PRODUCT INFORMATION BULLETIN

Date: September 11, 2017
Number: 12046
Division: Genie®
Product Family: Residential Opener Service Parts
Product Series: Circuit Boards
To: All Genie Professional Line Wholesalers, Dealers and Installers
Re: Replacement Circuit Boards (Rhine Units)

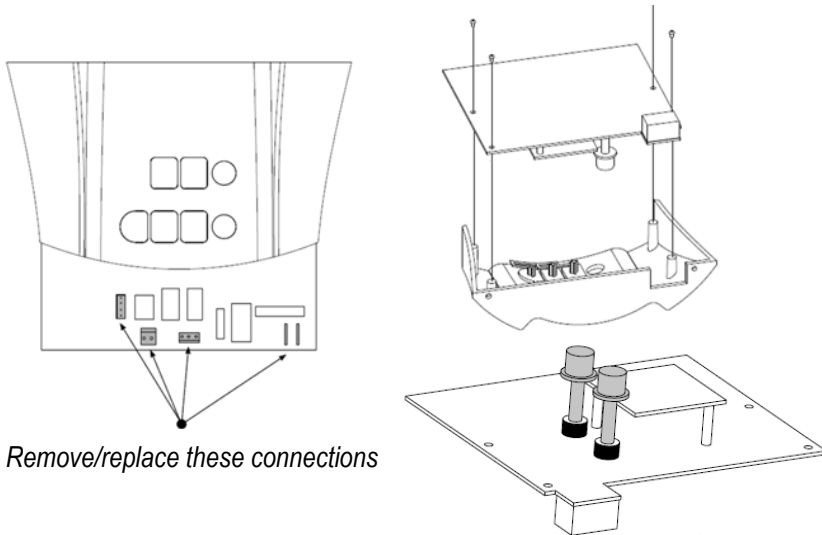
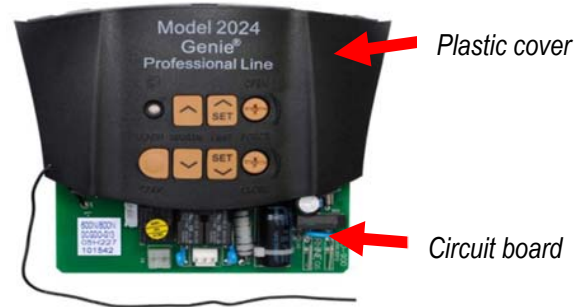
Previously, the below circuit board assemblies have always come with a plastic cover, such as the one shown in the image below (text by model). To help reduce the number of service board SKUs needed in the field, once these specific part numbers are depleted, they will no longer come with the plastic cover piece attached – it will be the board only.

The only added steps from the board with the plastic to the new part number is to remove 4 screws attaching the plastic to the board, gently pulling the antenna wire through and removing and reinserting force control shafts from the original board onto the new board.

37028E.S	Circuit Board (Black), Model 1024
37028G.S	Circuit Board (Blue), Models 1022/1042
37028A.S	Circuit Board (Black), Model 2024
37028C.S	Circuit Board (Blue), Model 2022 OBSOLETE use PN 39537R.S (no cover)
37028D.S	Circuit Board (Blue), Model 2042 OBSOLETE use PN 39537R.S (no cover)
37028J.S	Circuit Board (Gray), Model 2022-700 OBSOLETE (can use 37028L.S)
37028L.S	Circuit Board (Gray), Model 2027
